SUBJECT: **Request for Modification to the Section 404 Individual Permit and Section 401 Water Quality Certification** for the proposed Greensboro Eastern Loop from US 70 Relocation to SR 2303 (Lawndale Drive), Guilford County, Division 7. WBS Element No. 34821.1.1, TIP Nos. U-2525B and U-2525C.

The area of new impacts (Permit Site 11A) was overlooked prior to the original permit application submittal. The wetland impacts for Permit Site 11A include <0.01 acre of permanent fill of Class II rip-rap for the proposed bridge bent protection (Table 1). Please replace the current permit drawings with the new revised drawings (Revised Permit Drawing Sheets 1, 36, 37, 89, and 93 of 93), all attached with this letter.

WETLAND AND SURFACE WATER IMPACTS PERMIT

-Y7- POT Sta. 10+00.00
PERMIT DRAWINGS
SHEET 37 OF 93
 29 MICHAEL A. FOWLER Revised
 11/20/2014

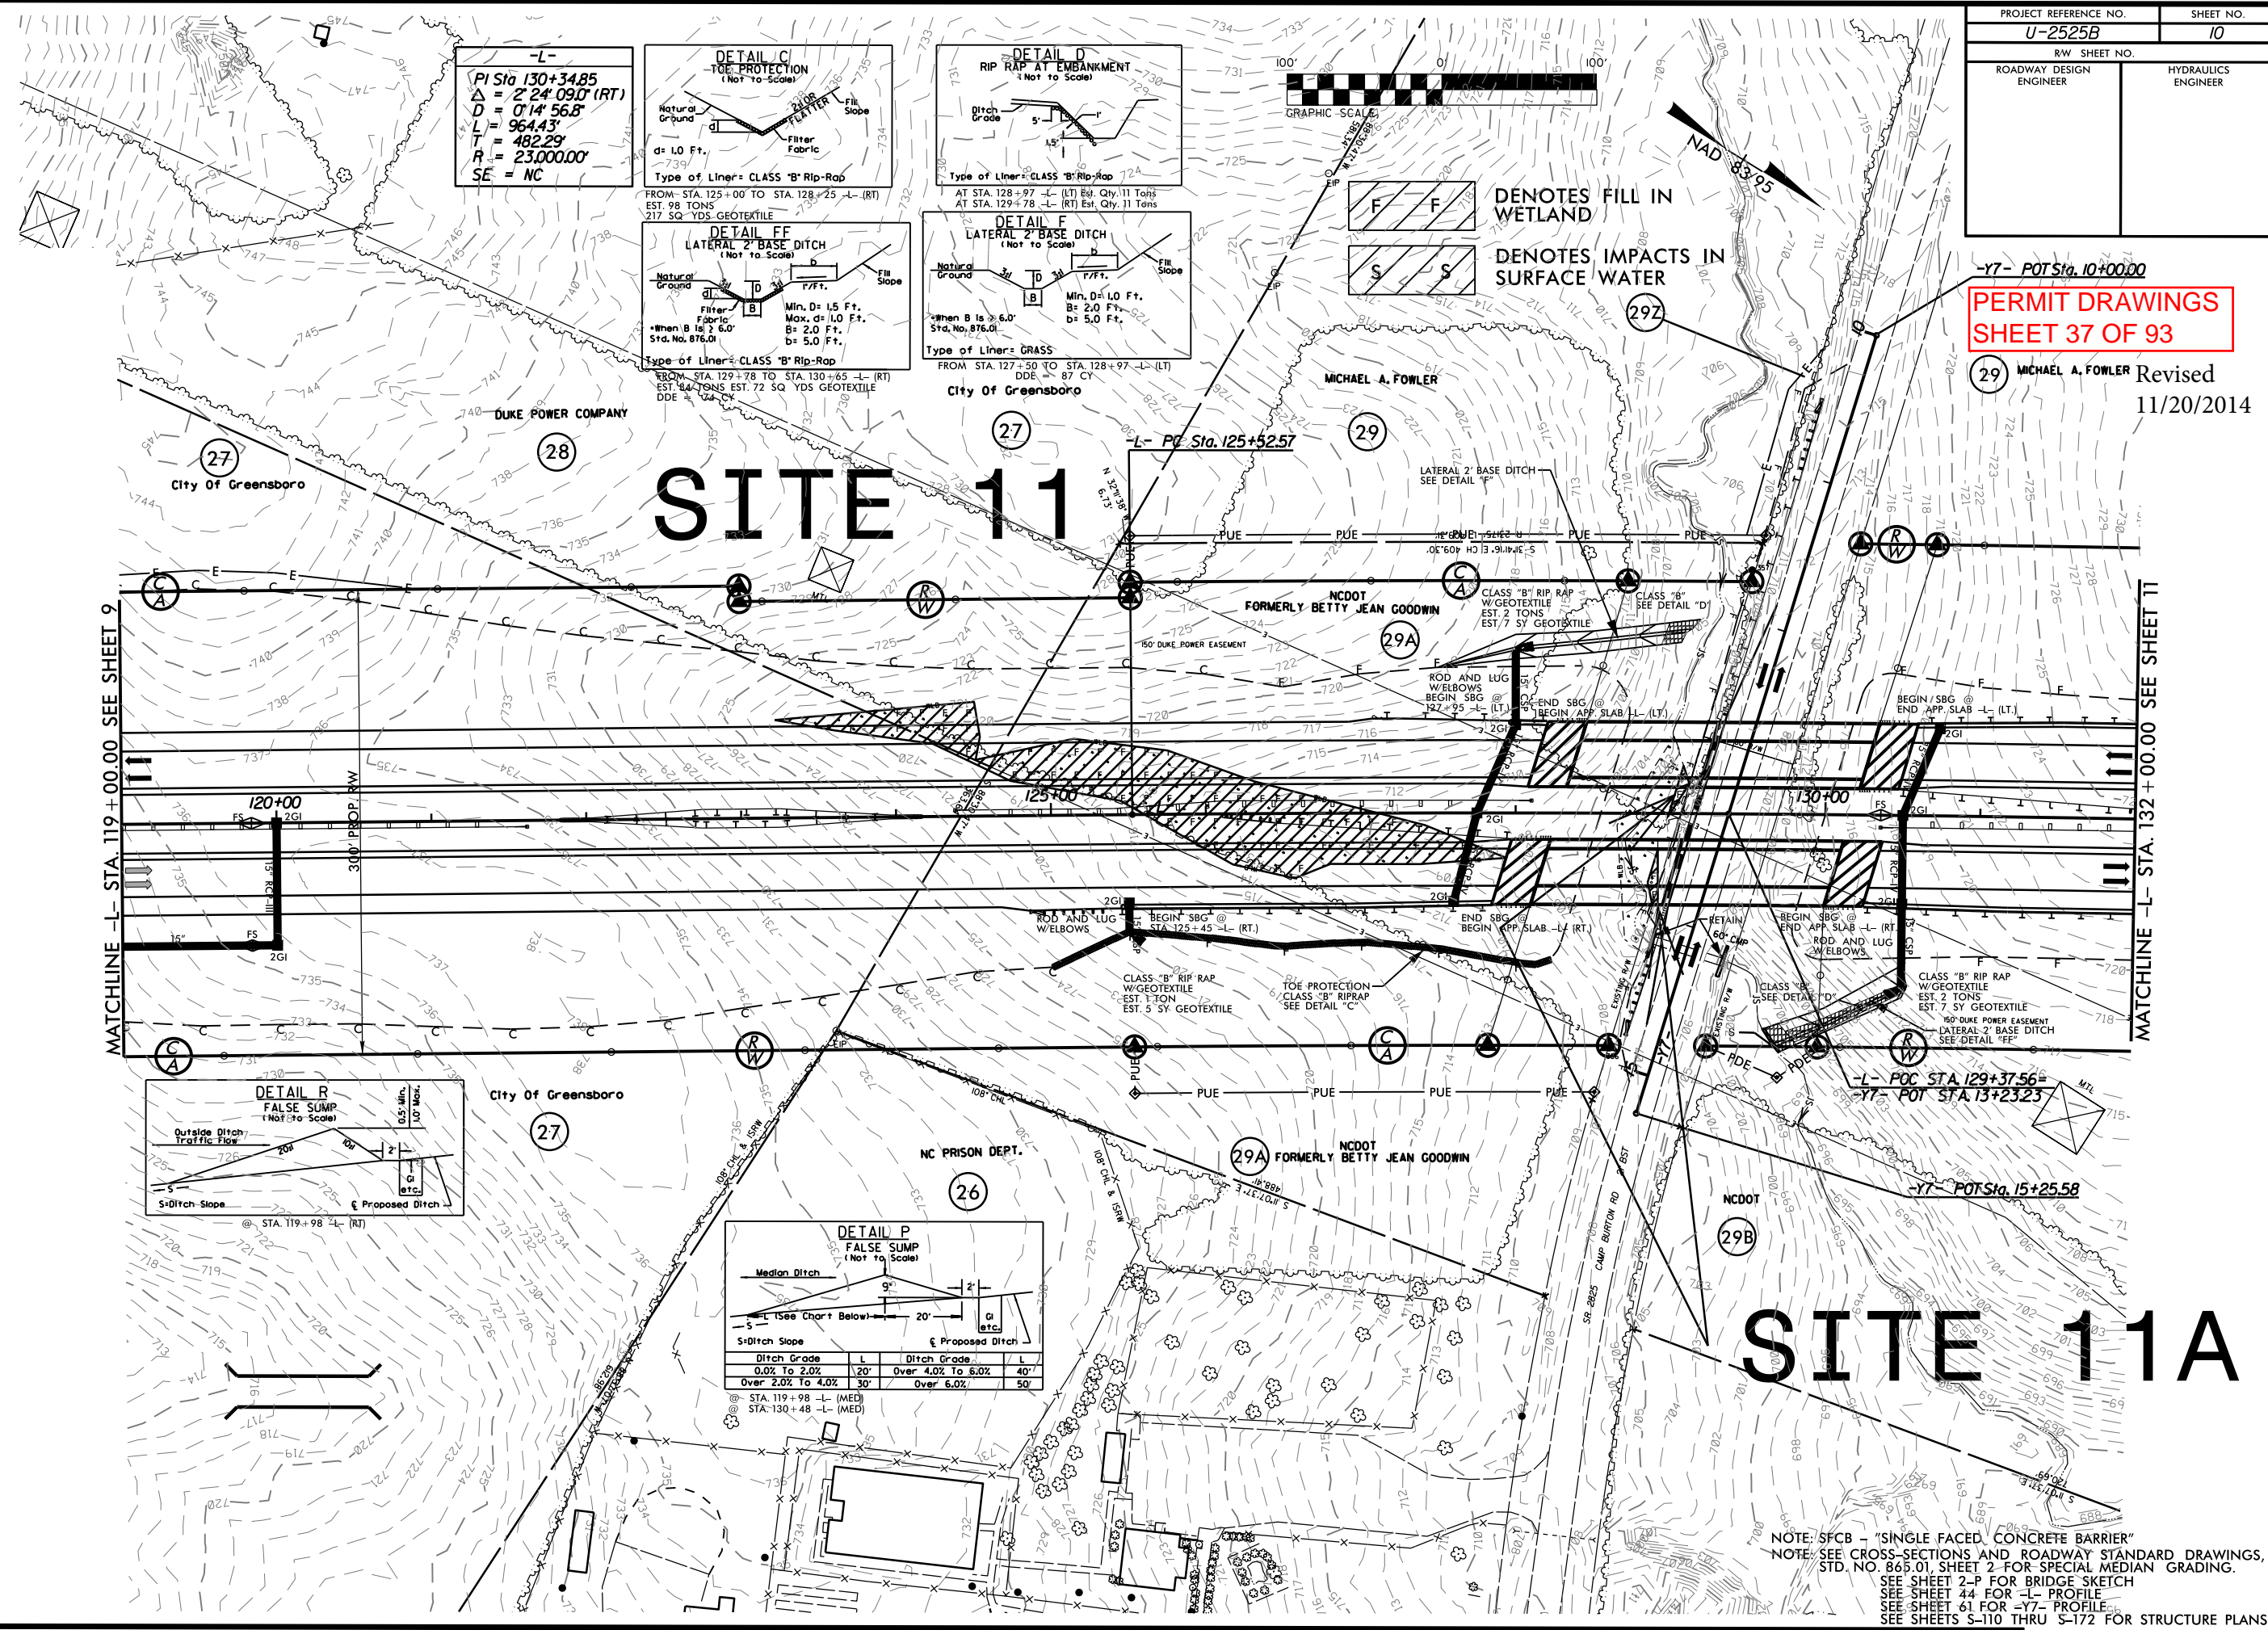
SITE 11A
